35/13-00Q 2 Newlands Street  
(Chevy Chase Village Historic Dist)

SUBJECT: Historic Area Work Permit Application - HPC Decision

<b>Address:</b>	2 E. Newlands Street, Chevy Chase	<b>Meeting Date:</b>	06/28/00
<b>Resource:</b>	Chevy Chase Village Historic District	<b>Report Date:</b>	06/21/00
<b>Case Number:</b>	35/13-00Q	<b>Public Notice:</b>	06/14/00
<b>Review:</b>	HAWP	<b>Tax Credit:</b>	None
<b>Applicant:</b>	Richard & Barbara McMillan (Cynthia W. Hinchman, Agent)	<b>Staff:</b>	Perry Kephart
<b>PROPOSAL:</b>	Window Replacement	<b>RECOMMEND:</b>	Approve

NORTH PORCH  
McMILLAN HOUSE  
#2 NEWLANDS ST, CHEVY CHASE, MD

NORTH PORCH  
McMILLAN HOUSE  
#2 NEWLANDS ST, CHEVY CHASE, MD.

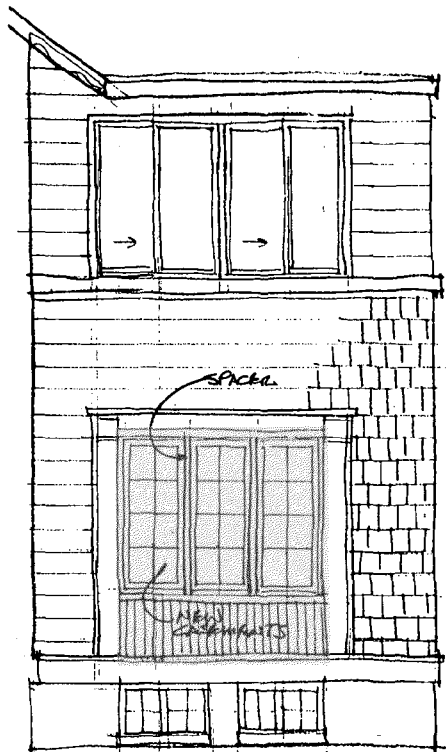
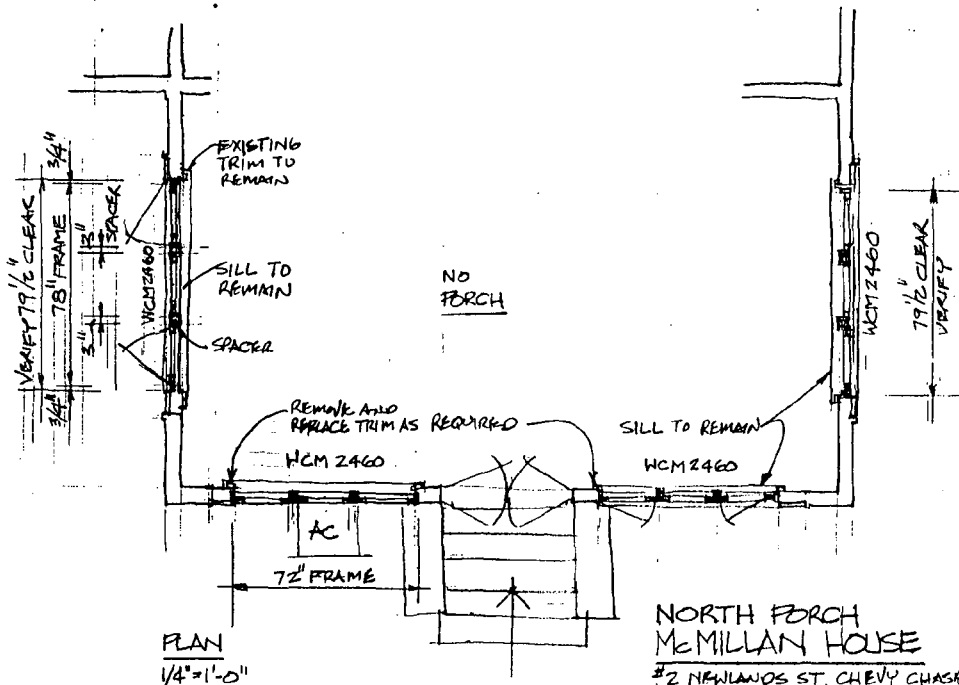
The applicant proposes to replace the out-of-period aluminum windows with wood framed, 6-light, true divided-lite, casement windows.

The applicant is to be commended for replacing out-of-period windows with windows more in keeping with the period of the house.

Staff recommends that the Commission *approve* the HAWP revision as being consistent with Chapter 24A-8(b)2:
